33485 Vinewood in
 Lot 24, Block 2
 Quetta Woods
 Seward, AK

From: "Wall, Bruce" <bwall@kpb.us>
Date: April 29, 2016 at 3:42:28 PM AKDT
To: "'lizdemoss26@yahoo.com'" <lizdemoss26@yahoo.com>
Cc: "Ring, Katie" <kring@kpb.us>
Subject: Marijuana Establishment Application (License 10122)

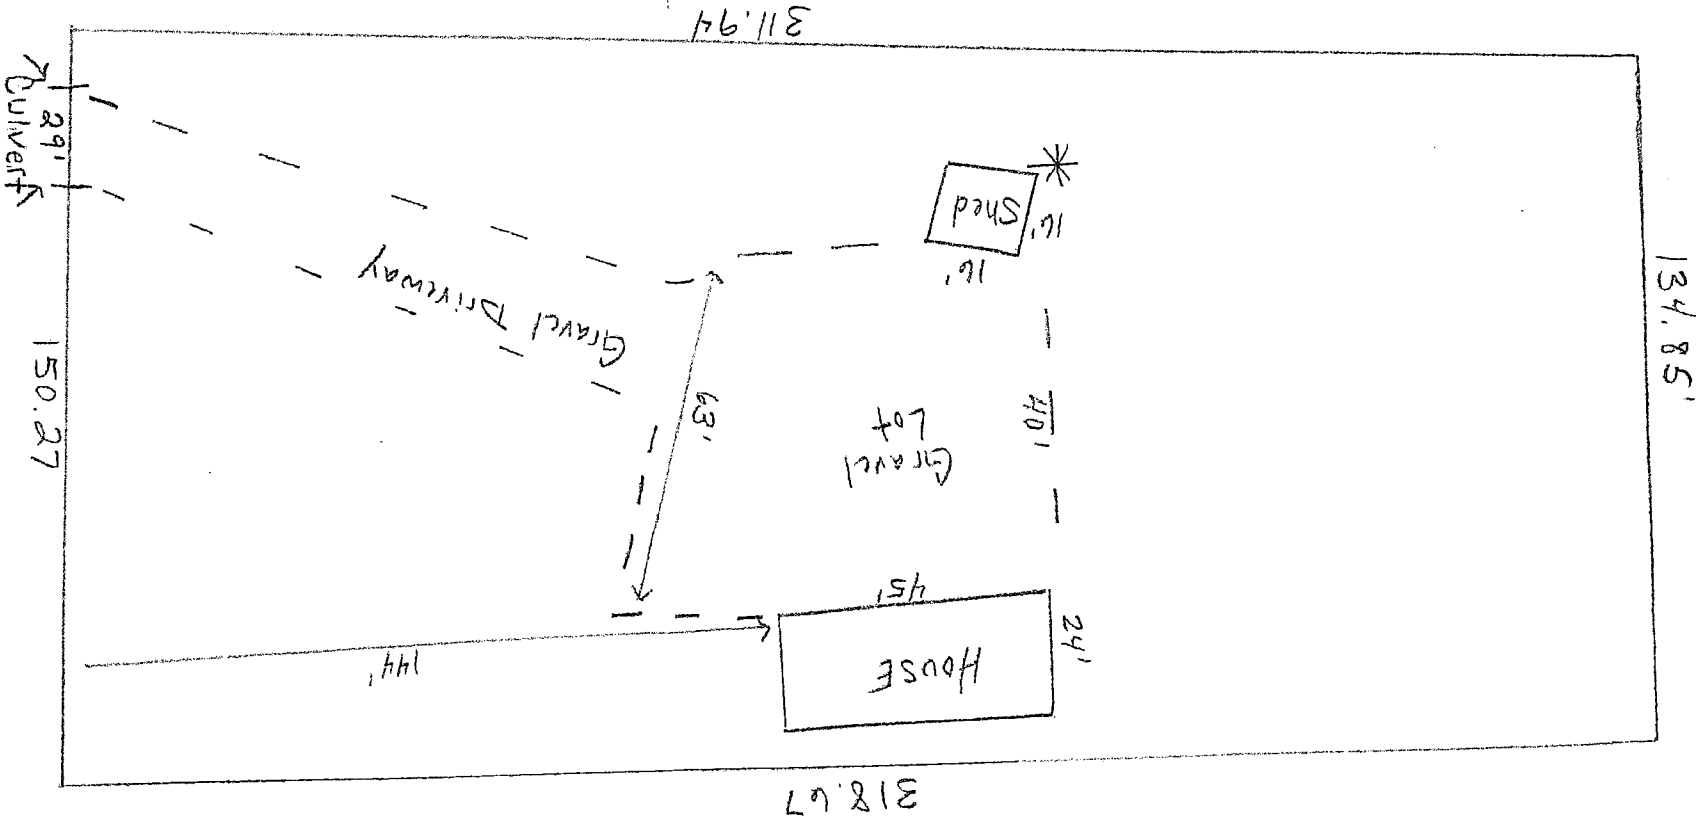
In reviewing the site plan that you have submitted, it is not clear what the width of the driveway is where it accesses Vinewood Lane. KPB 7.30.020C requires a 28-foot width at the access point. Please provide an updated site plan that clarifies this issue.
